SUNDRY NOTICES AND REPORTS ON WELLS (DO NOT USE THIS FORM FOR PROPOSALS TO DRILL OR TO DEEPEN OR PLUG BACK TO A DIFFERENT RESERVOIR. USE "APPLICATION FOR PERMIT" (FORM C-101) FOR SUCH PROPOSALS.)		WELL API NO. 30-015-26306

2. Name of Operator ConocoPhillips Company on behalf of Parrish, H Dwane & Rhonda K		6. State Oil & Gas Lease No. L-2634
3. Address of Operator 913 N. Eldridge Parkway Houston, TX 77079		7. Lease Name or Unit Agreement Name Merci State

PROPOSED
Wellbore Diagram

Operator: CONOCOPHILLIPS COMPANY 600 W. Illinois Avenue Midland, TX 79701	OGRID: 217817
	Action Number: 365595
	Action Type: [C-103] NOI Plug & Abandon (C-103F)

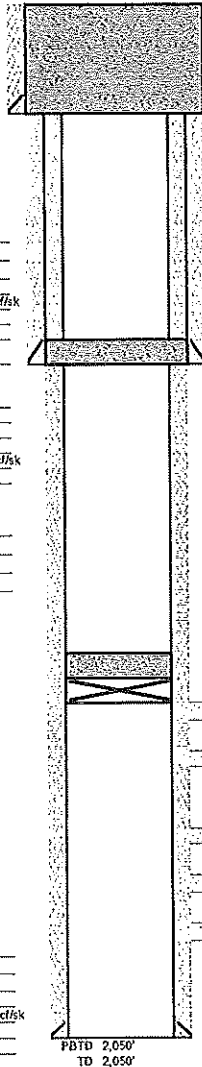
3. Spot 25 sx cmt @ 1778-1430'.
2. Circ hole w/ 10 ppg brine H2O. Pressure test csg to 500 PSI for 30 mins.
1. Set 4 1/2" CIBP @ 1778'. Run CBL from 1778' to surface.

Created By	Condition	Condition Date
loren.diede	Notify NMOCD 24 hours prior to beginning P&A operations.	9/9/2024
loren.diede	CBL tif file is to be uploaded into NMOCD Imaging.	9/9/2024
loren.diede	NMOCD does not consider this well to be within the LPCH area. An above-ground P&A marker is required.	9/9/2024
loren.diede	Review the R-111 potash requirements due the proximity to posted R-111 potash areas.	9/9/2024
